Road Safety Audit Stage 2

Mold Road, Gwersyllt

Title: Road Safety Audit Stage 2, Mold Road, Gwersyllt

Road Safety Audit Decision Log

ITEM 2-4

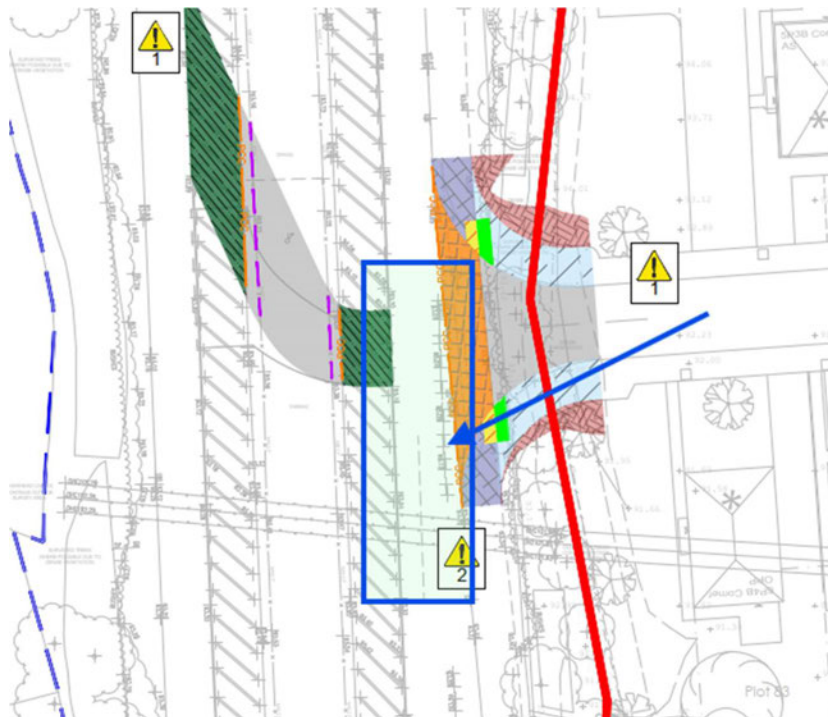
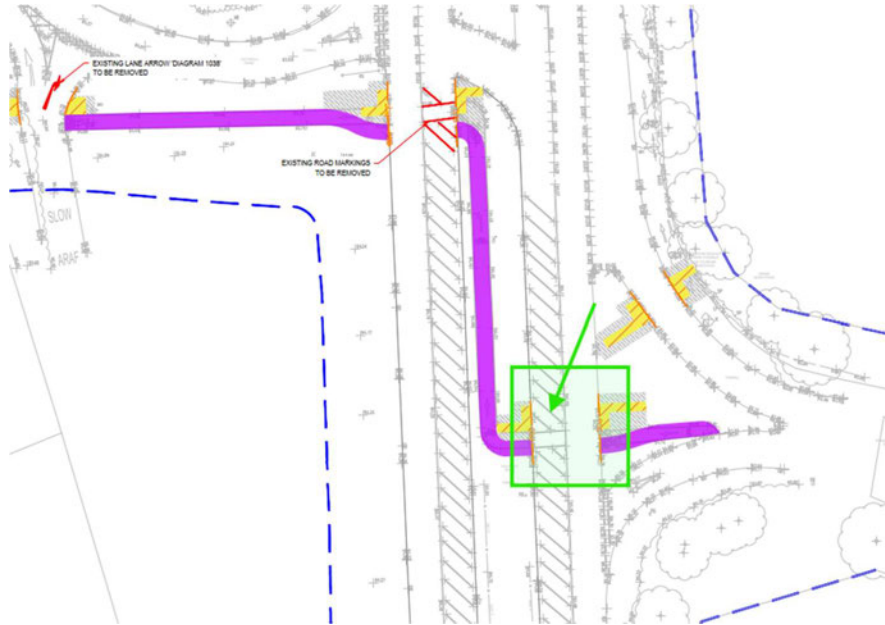
Drivers could become confused if old road markings are not fully removed before the new markings are implemented

The scheme will introduce a large number of changes to the carriageway and the associated carriageway markings. If the new carriageway markings are laid on top of the old carriageway without fully removing the old ones, drivers could become confused as to where they should be positioned with the carriageway or where they should stop or give way. This could result in drivers making inappropriate manoeuvres and/or failing to stop or give way resulting in collisions with other vehicles or pedestrians/cyclists.

Ensure the existing carriageway markings are fully removed or that the carriageway is resurfaced.

Partially accepted

SCP – R2-4 – Site clearance drawings includes details of the existing carriageway markings that are to be removed as part of the interventions. It is acknowledged further removal of road markings at the proposed signalised crossing (southbound – Mold Road – see below in green) and length of redundant intermittent road marking associated with the taper south of the proposed access and associated diverge arrow (see below in blue) will be required and these will be included upon agreement of actions with the LHA.

ITEM 2-5

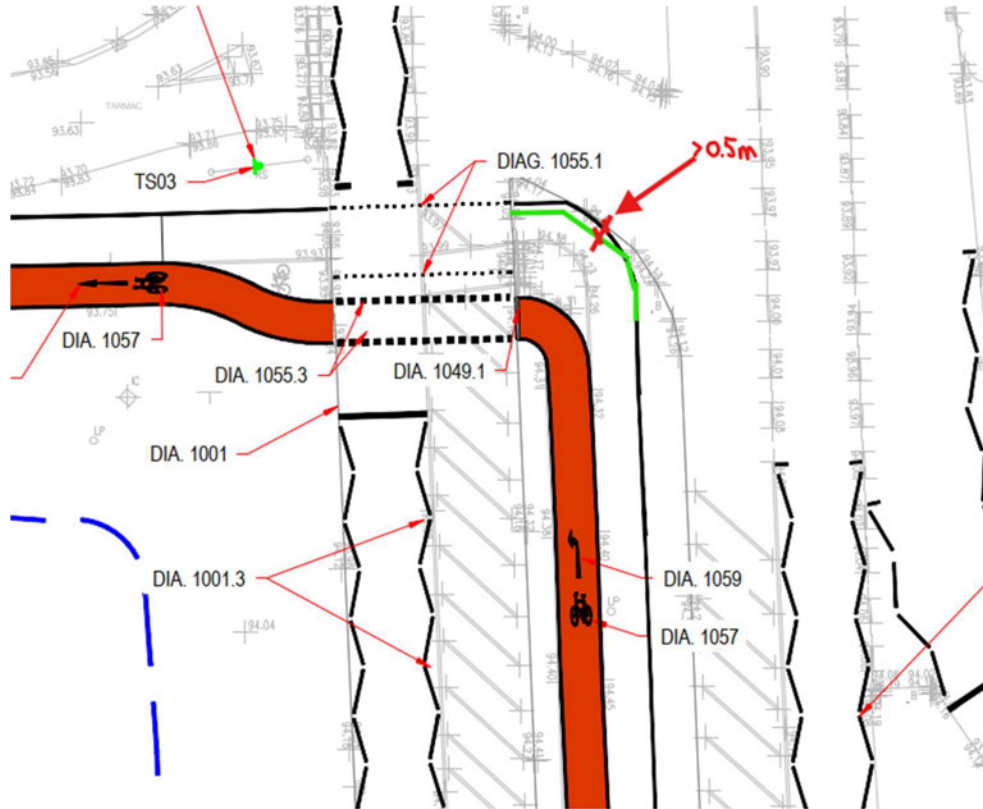
A lack of clear separation between the new footway and carriageway will increase the risk of vehicles striking pedestrians on the new footway increasing the risk of injury

It is proposed to provide a footway between Old Mold Road and Stansty Chain Road following the route of the existing cycle facilities. Where the footway crosses the central reservation, it is noted that the footway and tactile paving will be very close to the right turn (central reservation crossing) for vehicles exiting Old Mold Road. A lack of clear separation between the new footway and carriageway will increase the risk of vehicles striking pedestrians on the new footway increasing the risk of injury.

It is recommended that as a minimum at least 500mm is provided between the edge of the footway and the carriageway to create an area of separation.

Accepted

SCP – R2-5 – The location of the proposed pedestrian crossing and associated crossing facilities will be shifted south (both sides of the crossing) to provide a minimum 500mm buffer from the central reservation kerbline

ITEM 2-6

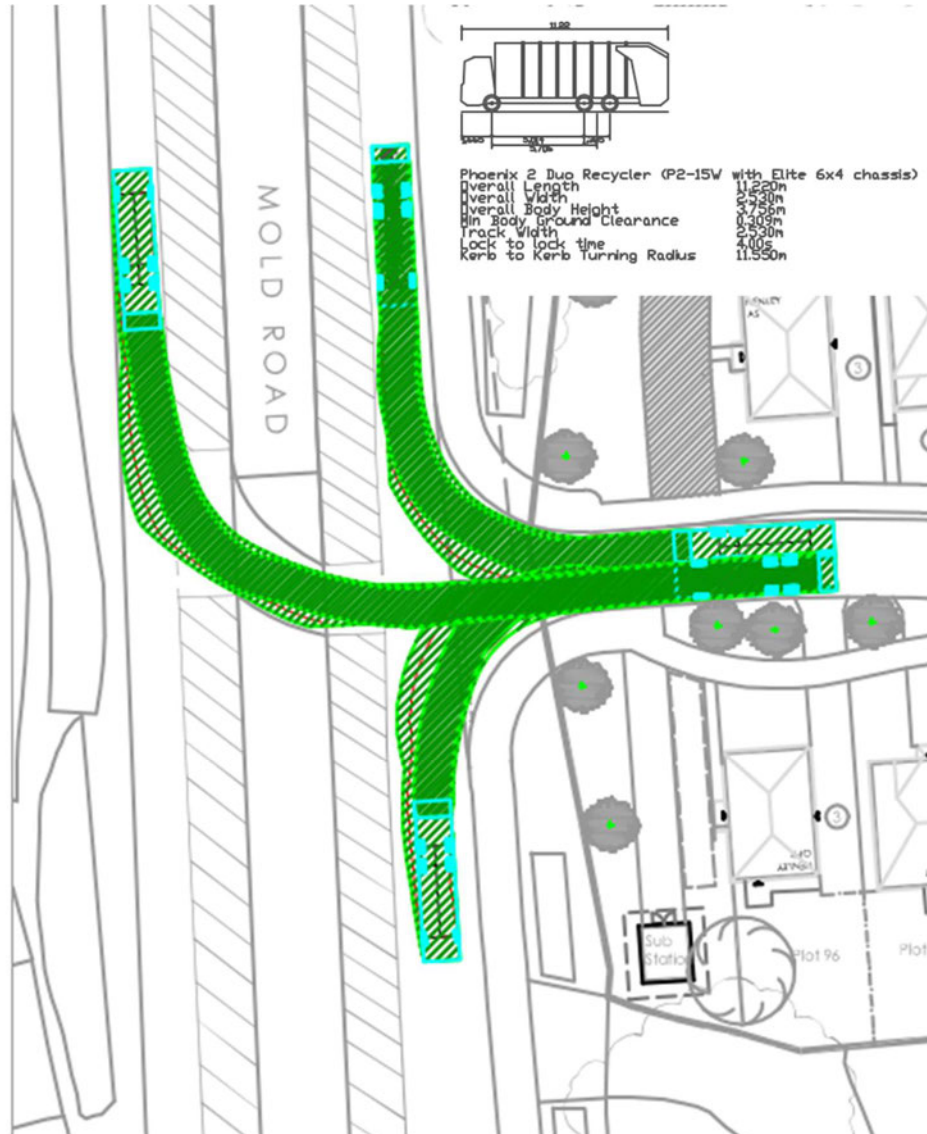
Inappropriate carriageway widths and turning radii can result in increased vehicle collisions as well as pedestrian/vehicle collisions

Vehicle tracking details were not submitted as part of the RSA information. It is important that all vehicles which are expected to use the access, can safely negotiate the junction. If vehicles cannot safely turn into or out of the access without overrunning the kerbed areas around the junction mouth, there is a risk conflicts between vehicles using the access, and on-going maintenance issues.

Ensure that all vehicles that are expected to turn into and out of the access, can do so safely without impacting on other junction users.

Rejected

SCP – R2-6 – Vehicle tracking was completed as part of the planning process and liaison with the highways officer (drawing SCP_220743_ATR01 – extract below) which shows how vehicle negotiate the junction with no kerb overrun.

ITEM 2-7

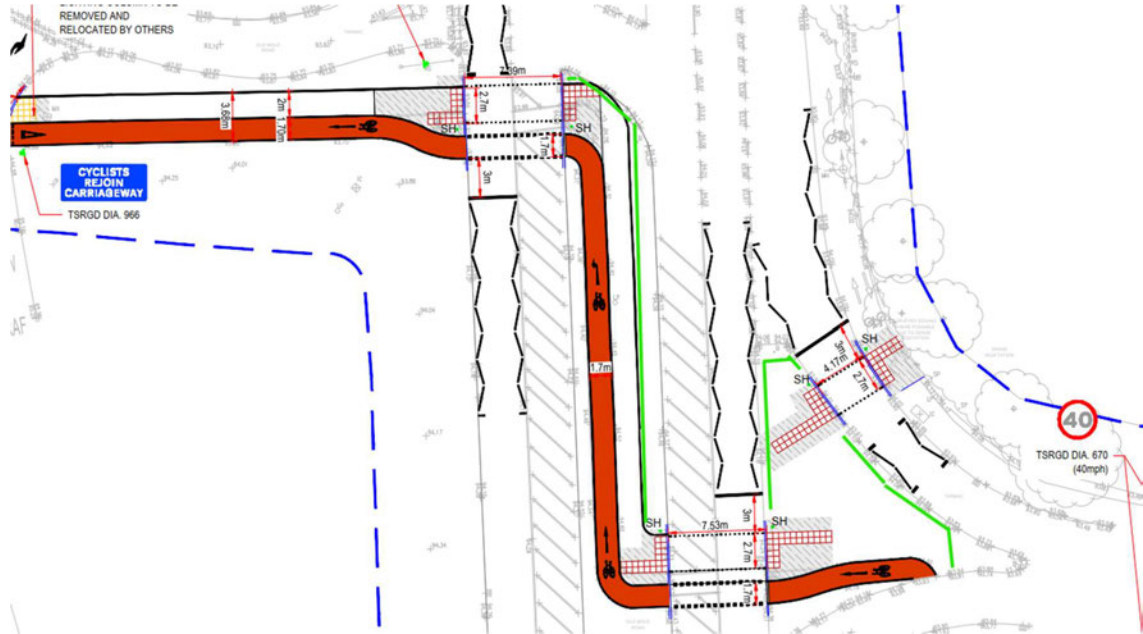
A lack of edging kerbs and pedestrian guard railing will increase the risk of injury to visually impaired pedestrians

This problem is carried forward to the RSA 2 as it has not been addressed. New footway is to be created across Mold Road. It is unclear how visually impaired pedestrians will be accommodated over the various islands as there is limited guidance, particularly for visually impaired users, to ensure that the various crossing points can be safely located and that the 90-degree bends currently proposed can be negotiated by cyclists. A lack of edging kerbs and pedestrian guard railing will increase the risk of injury to visually impaired pedestrians.

Consider how the visually impaired will be accommodated along the new footpath and how they will be guided between the controlled crossings by considering the introduction of pedestrian guardrail at various key locations around the junction. Also ensure that the layout is compliant with LTN 1/20

Accepted

SCP – R2-7 – SCP proposes the introduction of pedestrian guardrail as shown below in green to be agreed with the LHA.

ITEM 2-8

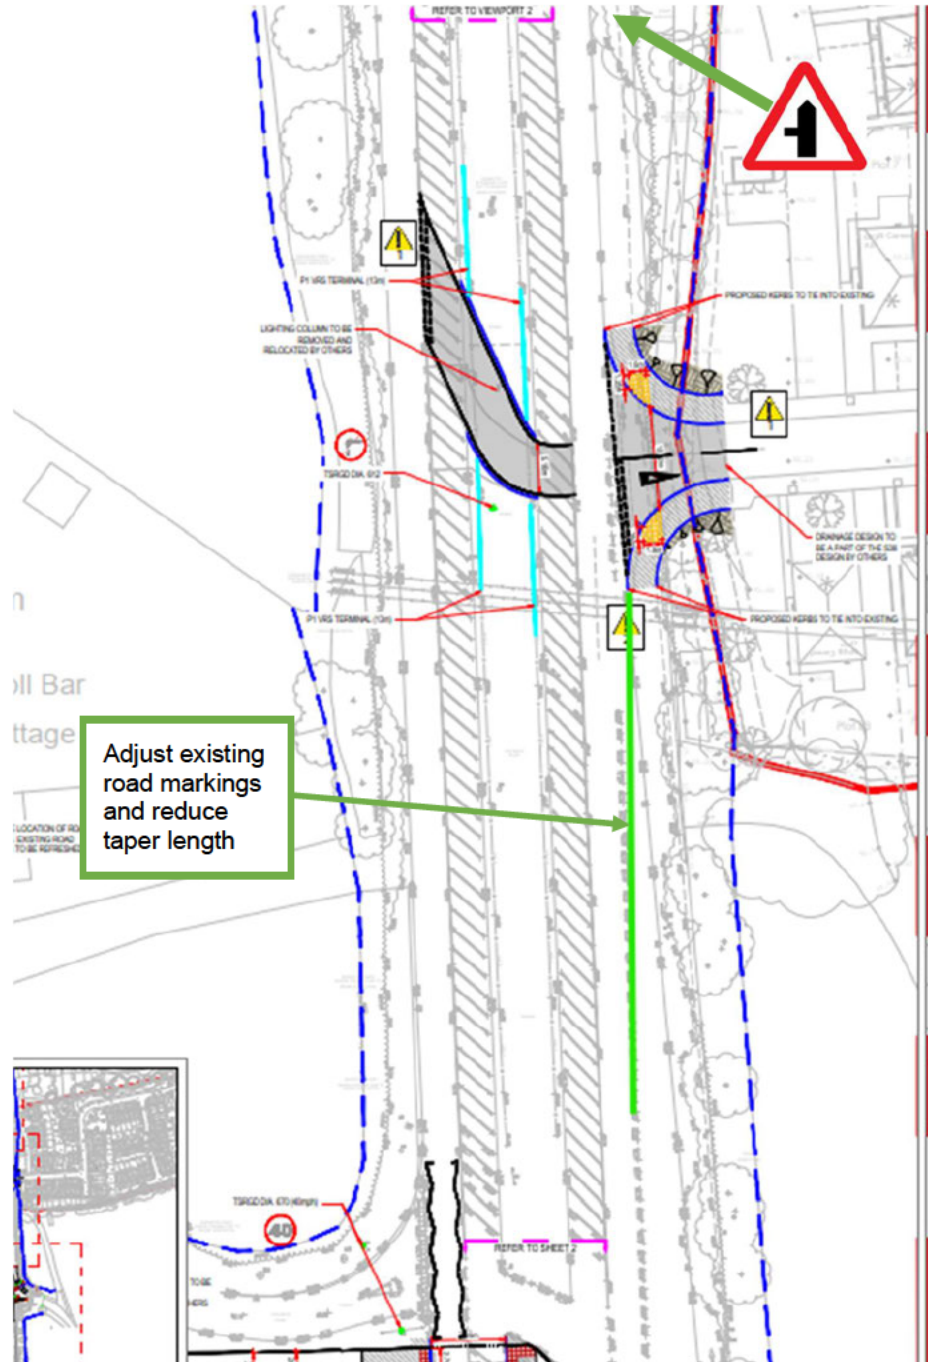
Closely located junctions can increase the risk of drivers failing to give way

It is proposed to construct a new priority junction that allows left in, left out and right out turning movements. No vehicles will be able to turn right from Mold Road into the site but must travel north and use the St Giles Park roundabout to undertake a U-turn manoeuvre to access the development.

The Audit Team did consider that there was a risk of drivers travelling to Stansty Chain Road indicating to pull left from Mold Road prior to the site access junction. This could be confusing to drivers pulling out of the proposed access in error into the path of an approaching southbound vehicle. It is considered that this is exacerbated by the close proximity of the site junction and the diverge.

It is recommended that the taper diverge is reduced in length so that the diverge point which is very close to the site access junction is moved south and that a level of separation is created. This should be achievable as the design speed of Mold Road will be reduced by the relocation of the speed limit. It is also recommended that signing is introduced to help delineate between the new junction and Stansty Chain Road junction.

Partially Accepted

SCP – R2-8 – The existing taper will be proposed to be reduced by adjusting the existing road markings for a reduction in the taper so it starts immediately south of the site access. Furthermore, the introduction of a warning sign to TSRGD diagramme 506.1 advising the presence of a side road ahead will help to mitigate the above problem.

ITEM 2-9

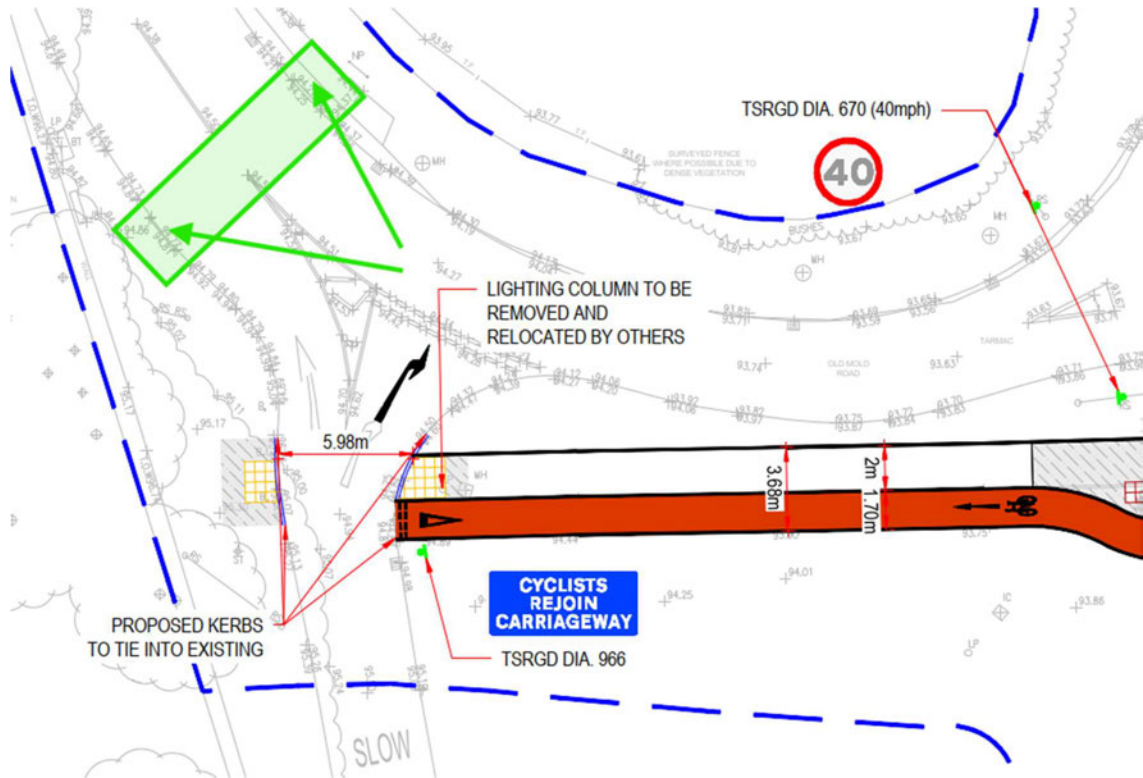
A lack of suitable uncontrolled crossings will increase the risk of collisions.

It is noted that the existing crossing of Old Mold Road located on the slip from Mold Road will be upgraded and provided with tactile paving. The footway terminates roughly 15m north of the upgraded route over Old Mold Road (slip from Mold Road). This results in pedestrians then crossing Old Mold Road to gain access to the footway along the eastern side of the road to continue their journey. This uncontrolled crossing does not have tactile paving. Which will lead to confusion for visually impaired pedestrians.

Tactile paving needs to be provided at the existing dropped crossing over Old Mold Road

Accepted

SCP – R2-9 – SCP agrees with the auditor and, though the inclusion of tactile paving was not part of the original approved layout, their inclusion as shown below in green is deemed beneficial.

ITEM 2-10

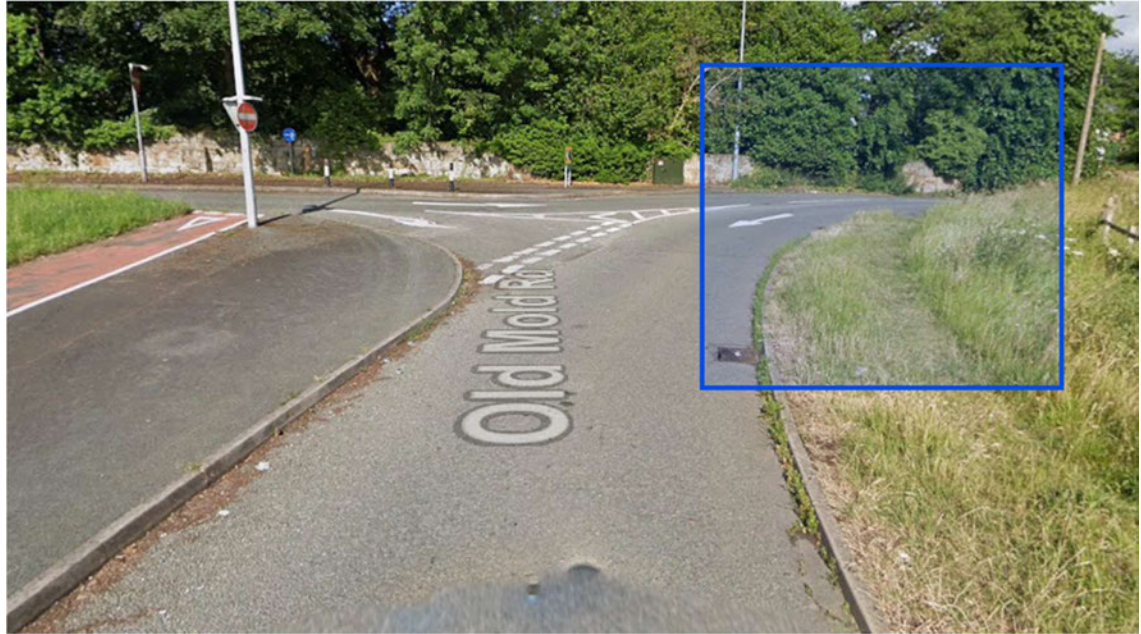
The Audit Team noted that the existing uncontrolled crossings of Old Mold Road do not correspond to the desire line observed by the Audit Team. Well-worn path in the verge indicates that pedestrians are not following the proposed route over Old Mold

Road (slip road). Instead, they are crossing Old Mold Road and walking along the verge.

The photos clearly show that this is a well walked route which would indicate that this is the preferred pedestrian desire line. The new development may well increase footfall and as such formalisation of this route should be considered by the designers. The current route is likely to be underutilised as it is convoluted and lengthy.

Formalisation of the established desire line that is shown in the photos should be considered as part of the design or introduce pedestrian route signing.

Rejected

SCP – R2-10 – It is understood the desire line shown on the pictures is the result of the lack of crossing facilities on Old Mold Road (northbound) which are proposed as part of these interventions. Furthermore, as raised in Item 2-9 the inclusion of an additional set of tactile paving will contribute towards formalising this arrangement. The introduction of a pedestrian crossing at the end of the desire line is not deemed safe as it would be located on a bend where visibility from the crossing to the right may be limited (see below in blue).
